Flight Procedures Cover Page	Task Action: FLIGHT CHECK	Task Type: IAP	Estimated Chart Date: 03/19/2026	APWS Task ID: 16BDA9FEE0234198B2483FA414C53EC6	APWS Project ID: ADB5B885B35444BD98C66E27013D2BA6
Procedure: RNAV (RNP) Z RWY 34R AMDT 1		Enroute: NO	Specialist: Dugan, Joshua		Agreement Number:
Airport ID: KDEN			Airport City: DENVER		State: CO
Facility ID:	Facility Type:	Flight Inspection Remark Type: New FC Slot			
Procedure Comments: ACTIVE DATA USED FOR KDEN NEW MISSED APPROACH APPROVAL LETTER FOR HIMOM SUBMITTED. KMZ FILES _1 0.20 AND 0.30 MISSED PENS _2 0.10 MISSED PENS CONTACT ROBERT HAMILTON AJV-A433 405-954-4608 10/08/25: THIS IS AN UPDATED COPY OF THE FORM DEVELOPED ON 07/17/25. 1. UPDATED MISSED APPROACH INSTRUCTIONS FROM CLIMB TO 10000 DIRECT PIPSY AND ON TRACK 307.84 TO OBOE AND ON TRACK 004.05 TO LPORT AND HOLD TO CLIMB TO 10000 ON TRACK 352.51 TO PIPSY AND ON TRACK 315.01 TO NIWOT AND HOLD. 2. PROFILE LINE 7 ADDED 34:1 IS CLEAR AND 20:1 IS CLEAR. 3. ADDED CHART SPEED ICON IN PLANVIEW AT BOOBU: MAX 210 KIA 4. PROFILE LINE 5 CHANGED 390 HAT TO 389 HAT. 5. CHANGED PBN REQUIREMENTS NOTE FROM "RNP AR APCH - GPS. AUTHORIZATION REQUIRED. FROM MCMUL: RF" TO "RNP AR APCH - G

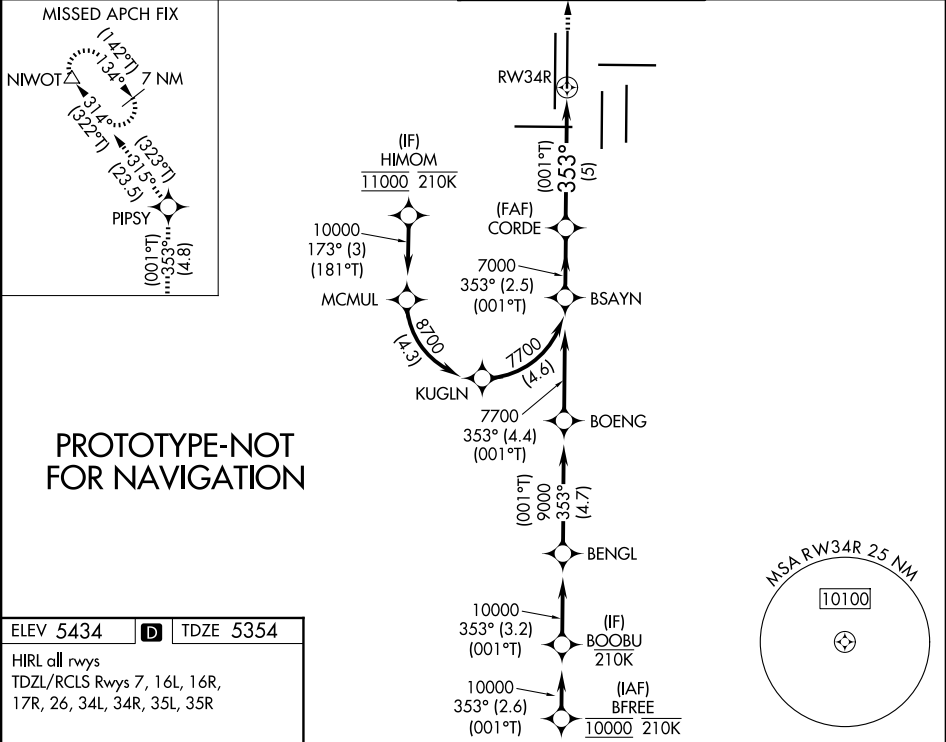
The intermediate segment for the RNAV (RNP) Z RWY 34R HIMOM to MCMUL has a mandatory altitude of 11000 MSL. The following four STARS that service KDEN have a mandatory altitude of 11000 MSL at HIMOM: AALLE ARRIVAL, FLATI ARRIVAL, LAWGR ARRIVAL and LONGZ ARRIVAL.

Per the 8260.3G 2-2-7f, an altitude restriction must be established at the termination fix of the STAR if the same fix is charted on an approach procedure. If the approach procedure fix has an altitude restriction associated with it, then the STAR termination altitude restriction must be identical to it.

This procedure has been flight checked and flown as satisfactory in both the current revision and previous amendments with the same mandatory altitude restriction with no issues noted by Flight Check, ATC operations or the flying public.

Requesting approval to continue to publish the mandatory altitude restriction at the intermediate fix HIMOM IAW the 8260.3G 2-2-7f criteria. It is not possible to easily convert HIMOM to an initial fix without significant redesign of the subsequent segment due to leg length and TF to RF requirements.
